NORTH ANNA POWER STATION, UNIT NO. 1

AMENDMENT NO. 54 TO FACILITY OPERATING LICENSE NO. NPF-4

SAFETY EVALUATION BY THE OFFICE OF NUCLEAR REACTOR REGULATION

SUPPORTING AMENDMENT NO. 54 TO
FACILITY OPERATING LICENSE NO. NPF-4
VIRGINIA ELECTRIC AND POWER COMPANY
OLD DOMINION ELECTRIC COOPERATIVE
NORTH ANNA POWER STATION, UNIT NO. 1
DOCKET NO. 50-338

FIGURE 2.1-1 REACTOR CORE SAFETY LIMITS FOR THREE LOOP OPEATION, 100% FLOW

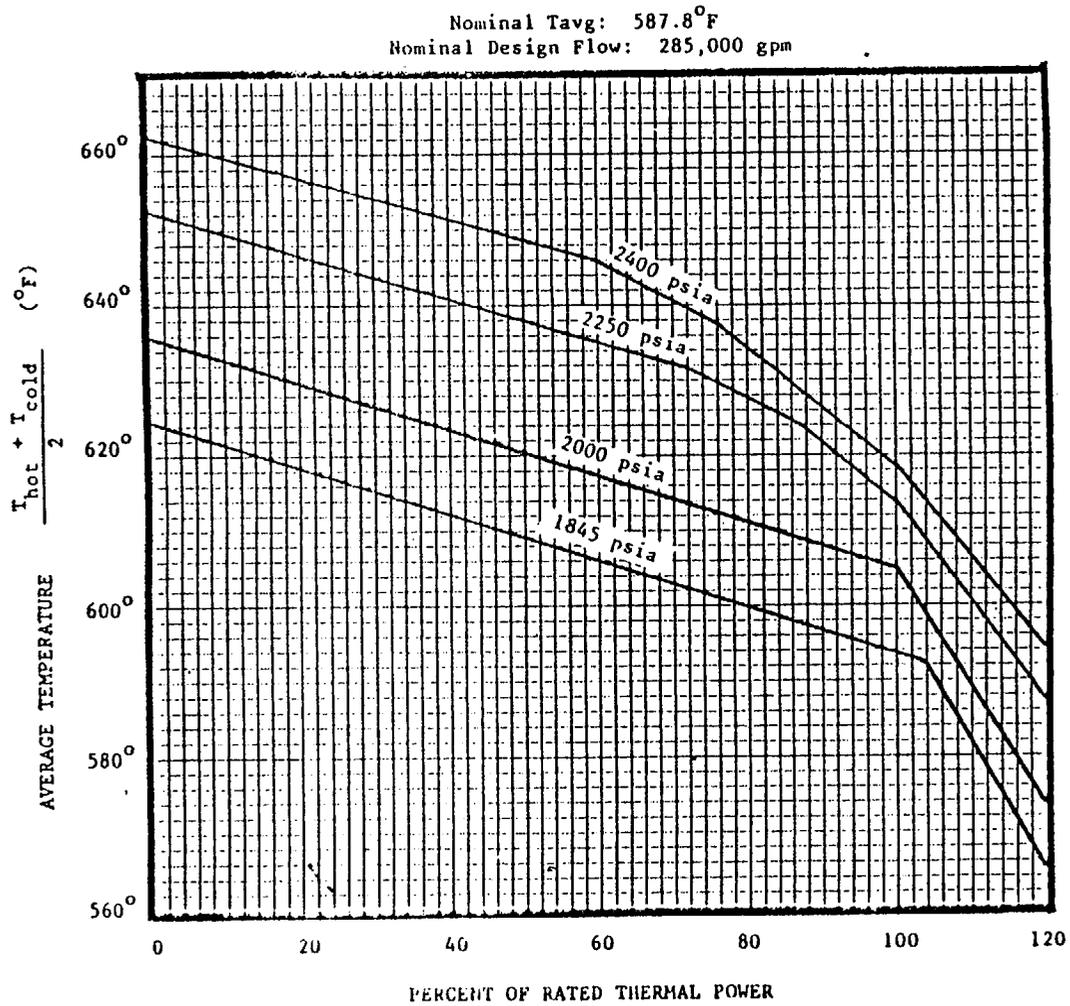
The amendment revises the NA-1 TS to allow operation with a Reactor Coolant System Average Temperature (RCS T_{av}) of 587.8°F. The amendment completes your Phase 1 and Phase 2 plant upgrade which increases secondary steam pressure in order to maximize the electrical output at the currently licensed reactor thermal power rating of 2775 Megawatts thermal. The amendment further revises the NA-1 TS to allow optimization of the core loading pattern by changing the fractional thermal power multiplier from 0.2 to 0.3 for a RCS T_{av} of 587.8°F.

Replace the following pages of the Appendix "A" Technical Specifications with the enclosed pages as indicated. The revised pages are identified by Amendment number and contain vertical lines indicating the area of change. The corresponding overleaf pages are included to maintain document completeness.

2.1.1 The combination of THERMAL POWER, pressurizer pressure, and the highest operating loop coolant temperature (T_{avg}) shall not exceed the limits shown in Figures 2.1-1 for 3 loop operation and 2.1-2 and 2.1-3 for 2 loop operation.
